REPORT

Based on the results of the review of the design and cost estimate documentation

Project: *“Capital Repair of the Kitchen Facility (Energy Efficiency Measures) at the Municipal General Secondary Education Institution Grades I–III ‘Varva Lyceum No. 2’ of the Varva Settlement Council, Pryluky District, Chernihiv Region, located at 54A Myru Street, Varva, Pryluky District, Chernihiv Region. Design Adjustment.”*

RP Stage (Detailed Design / Working Project)

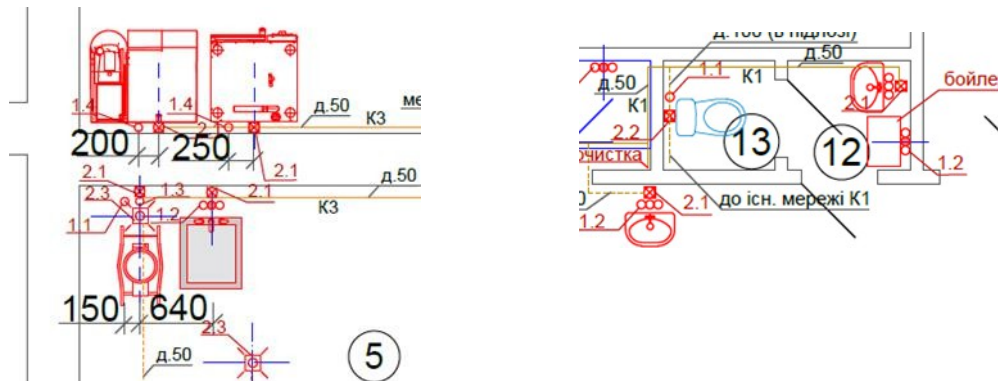
21. The notes for VK-3 specify the scope of demolition work (sinks, toilets, washbasins, etc.), but there is no demolition work plan, and the scope of demolition work is not specified in a separate specification.

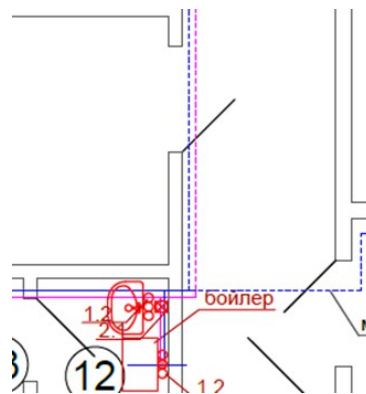
22. Drawing VK-5 shows the location references for pipe connections to equipment; however, the formatting and dimensions of the numbers violate DSTU 9243.7:2023 “System of Design Documentation for Construction.”

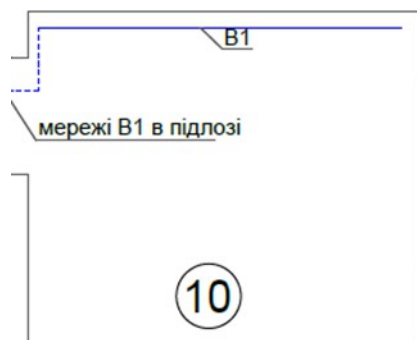
23. On the plan of water supply networks B1 and T3, sheet VK-4, sewer pipe outlets are mistakenly shown, which should be shown on drawings K3 and K1. Additionally, the legend lacks the designation of networks with a dashed line.

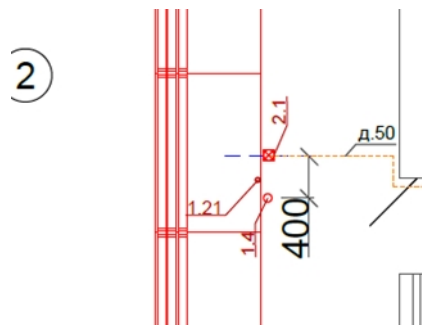
30. The VK-5 drawing does not show the slopes or the direction of drainage for the K3 system. All pipes from all fixtures (sinks, equipment, washbasins) are connected at a single point without any indication of the diameter of the existing network. Furthermore, the connection is made in a cross configuration, which contradicts the requirements of DBN V.2.5-64:2012. Specifically, Section 19.4 states: “For connecting drain pipes to the riser, diagonal tees and tees. Double-plane cross-pieces are an exception,” while Section 19.7 specifies: “The use of straight tees when they are located in a horizontal plane is not permitted.” Connections must be made with an offset in opposite directions branches at the connection point to the existing K3 network, to prevent backflow of wastewater.

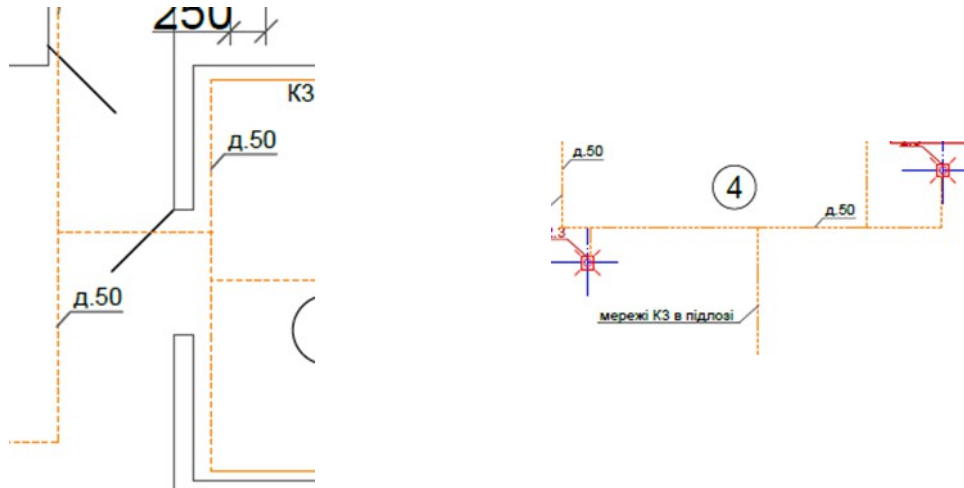
33. The draft does not provide for ventilation devices for the sewer system at the highest points (vent risers, vent valves), which does not comply with DBN V.2.5-64:2012, para. 19.17, according to which “The exhaust section of the sewer riser shall be led out through the roof or a prefabricated ventilation shaft of a house, building, or structure to a height of: a) from a flat roof that is not in use, and a pitched roof—0.2 m;”
